# Mandatory Service Bulletin

SB-MD10-007

Revision 02

Stabilizing of Tailwheel Cable

Figure 1: Spring assembly fastening onto tailwheel cable between bulkhead B8 and bulkhead B9

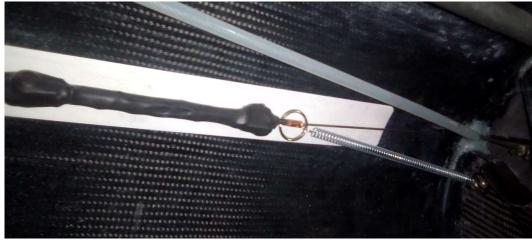
When the retractable tailwheel transport lockpin is installed and the main wheel is retracted, the tailwheel cable becomes slack. It was found that under some conditions, the slack cable may interfere with the fuel pump and cause resistance on the landing gear control cable, which could result in problems extending the landing gear. Depending on the configuration of the aircraft, this occurs in the compartment between bulkhead B8 and bulkhead B9. A soft tension spring is placed in the system with the SB to ensure the tailwheel cable is stabilised in the affected compartment in all conditions.

- The tailwheel cable stabilizing spring needs to be installed to all S/N named in section 1.C. For reference of the installed spring, see Appendix 1.
- Rectification according to Work Instruction, see Ref. /1/. Depending on aircraft configuration, removal of jet doors, jet engine box or water ballast tank is to be done according to Aircraft Maintenance Manual /2/, respectively /3/.
